Draft proposal for amendments to UN Regulation No. 43 (Safety glazing)

This document was prepared by the informal group on the introduction of plastic glazing for windscreens and laminated plastic panes other than windscreens in UN Regulation No. 43 (IGPG). It supersedes the informal document GRSG-104-43. The modifications to the current text of the Regulation are marked in bold or strikethrough characters.

Figure 6: Sand drop equipment

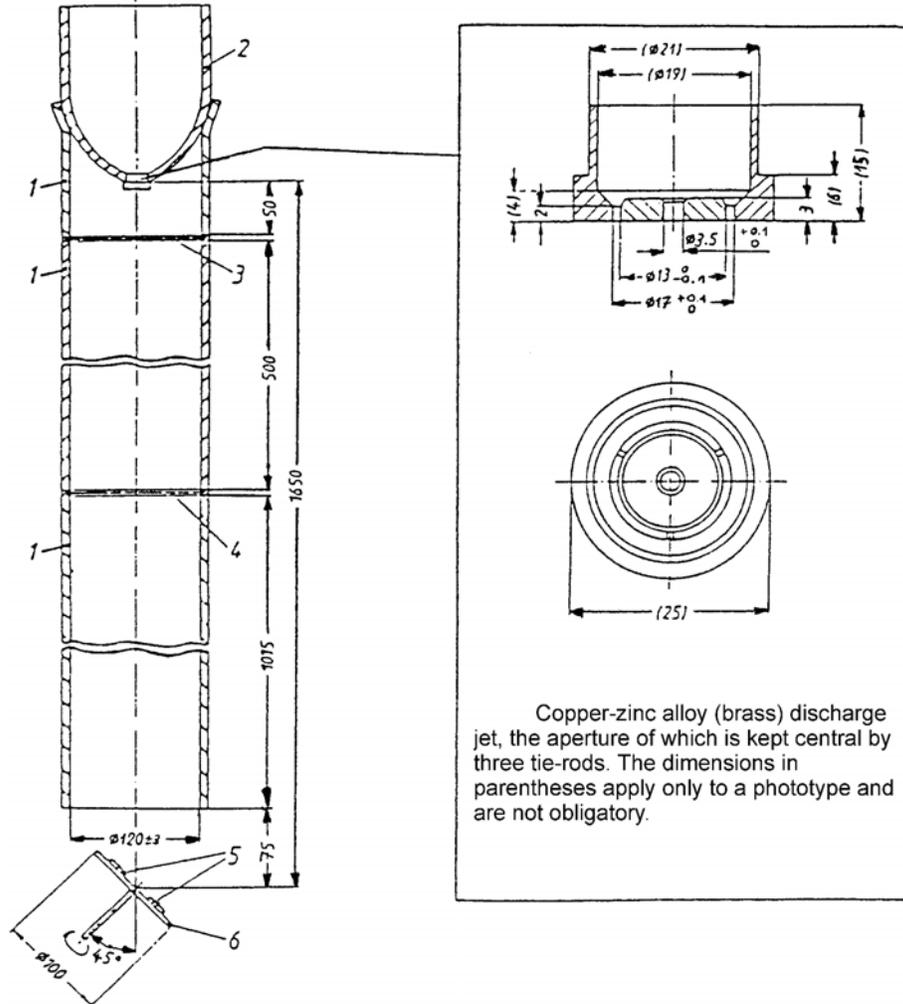
“4.7. Sand Drop Test

4.7.1. Apparatus

The sand drop test equipment shall consist essentially of that illustrated in Figure 6. The gravity tube consists of three separate rigid polyvinylchloride tubes (PVC hard) of the same diameter, with two polyamide sieves mounted in between. The sieves should have a mesh size of 1.6 mm. The speed of the turntable shall be 250 ± 10 rpm.

Figure 7: Movement pattern of washing brush and nozzle

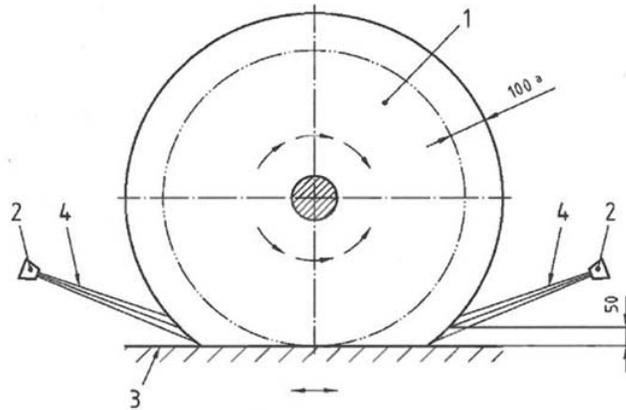
diameter	(1 000 ± 40) mm
width Minimum	300 mm
rotation speed	(127 ± 5) min ⁻¹
brush rotation	rotates in the opposite direction relative to the direction of travel of the test panel holder
material	polyethylene
bristle profile	x-shaped, spliced
bristle thickness	(0.8 ± 0.2) mm
bristle length	(440 ± 20) mm visible
penetration depth	(100 ± 20) mm (see figure 7)

The two nozzles shall spray alternately and against the direction of travel of the test panel holder. They shall produce the specified spray pattern (see instrument calibration in Figure 8).

Figure 8: Calibration arrangement

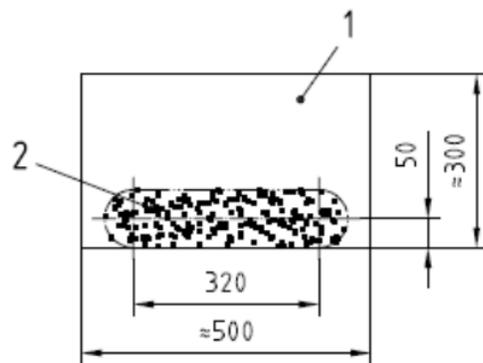
4.8.4.1.3. Do the instrument calibration as follows: Set up the equipment as shown in Figure 8. Fill with washing suspension (see paragraph 4.8.2. of this annex and wet the brush sufficiently. Determine the flow rate of the water, $(2.2 \pm 0.1) \text{ l/min}$, by measurement and adjust by altering the pressure, $(300 \pm 50) \text{ kPa}$. Check the spray pattern of the nozzles (see Figure 9) If the spray pattern cannot be achieved or if the pressure regulation exceeds the tolerances, check, and if necessary replace, the nozzles.

Figure 10: Description of sample positioning on the test holder

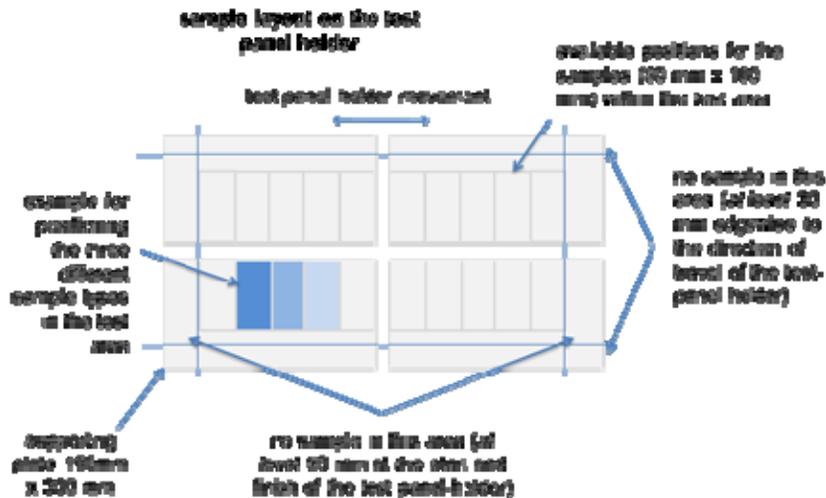
4.8.4.2.1. Affix the samples with the outside surface face up onto a supporting plate by using a double-faced adhesive tape (Sample positioning on the test holder as shown in Figure 10).

Figure 12: bird's-eye view of the apparatus

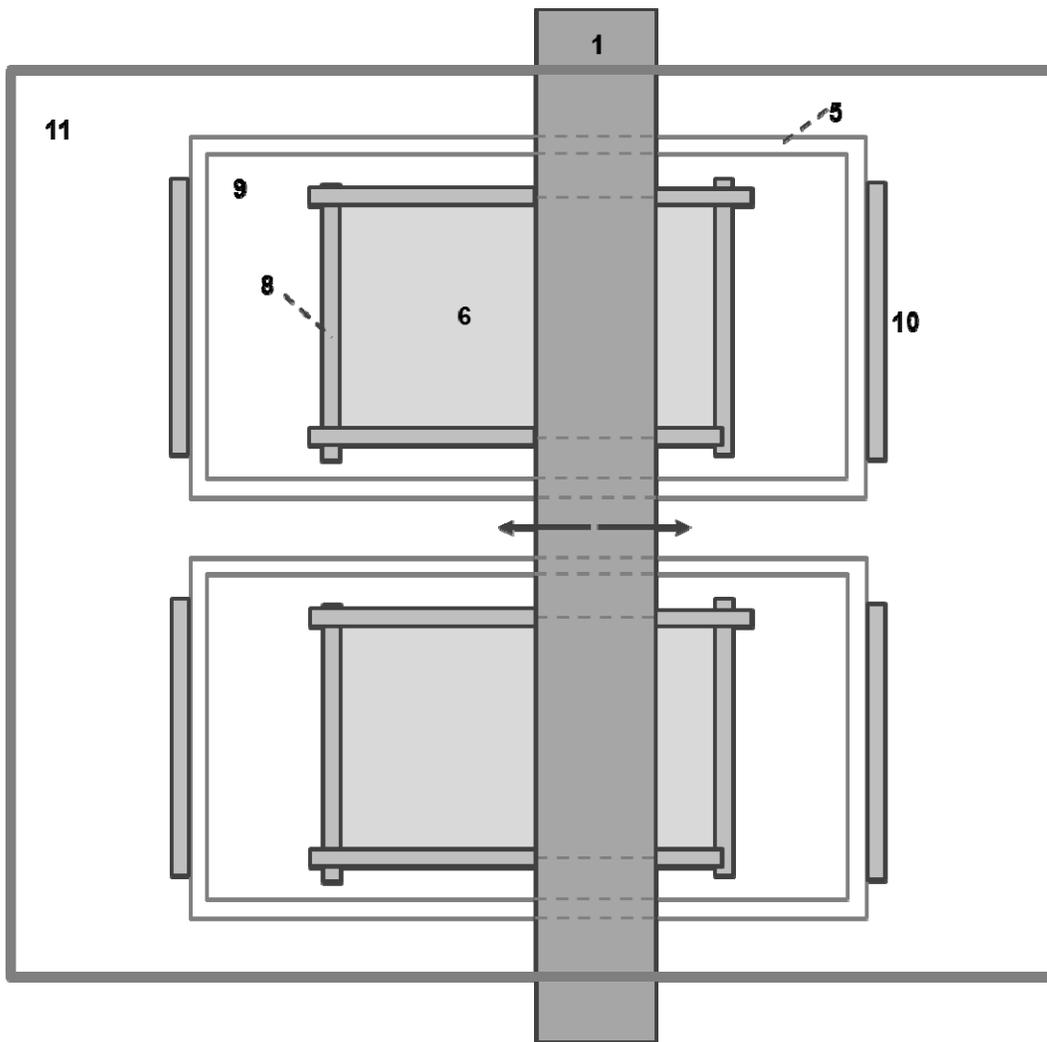
- 4.9.1.2. a wiper carriage assembly (see 1 in the figures 11 and 12) having a beam which spans across the width of the base apparatus and can be mounted at its ends to the pillars, furthermore this carriage assembly has two self-supporting arms (see 2 in the figures 11 and 12) where a wiper holder can be attached (the distance between the sample surface and bearing of self-supporting arm at the carriage assembly is 100 to 105 mm)

- 4.9.1.4. two sample boxes³ (see 5 in figure 11 and 12) made out of inert, material in the interior dimension of 200 mm x 120 mm (50mm height) used to be filled with the aqueous suspension and having a hole at the bottom⁴ where the test sample can be inserted and therefore used as a test sample holder

Figure 15: rearrangement of the sample boxes

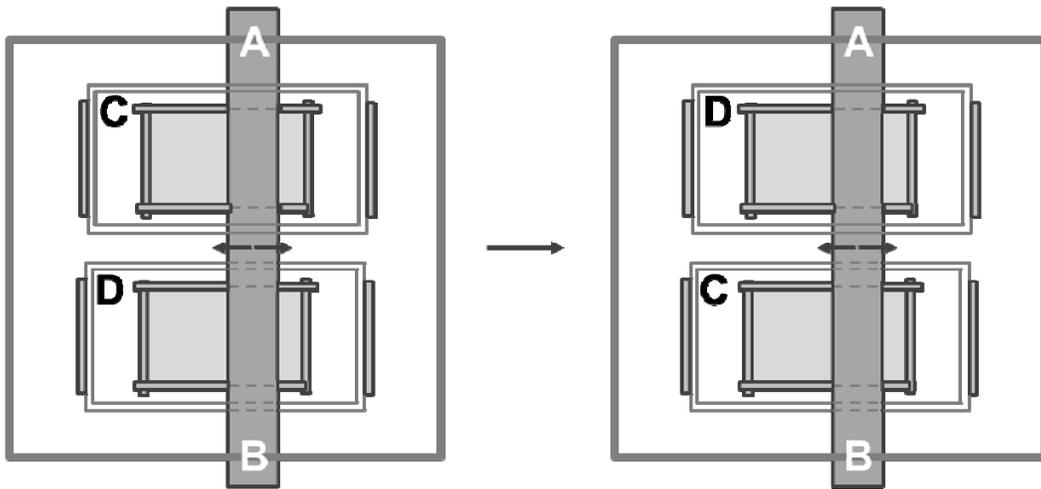
- 4.9.5.3.6. In order to ensure a homogenous abrading it is necessary to follow the action described below:
- 4.9.5.3.6.1. after half of the test cycle numbers ([10.000 cycles]) the test shall be stopped and the two sample boxes shall be exchanged without turning them (see figure 15)¹⁰; this leads to an exchange for the two simultaneously tested samples regarding their wiper blades and furthermore alters the alignment of the self-supporting arm carrying the blade (from left to right or the other way round).
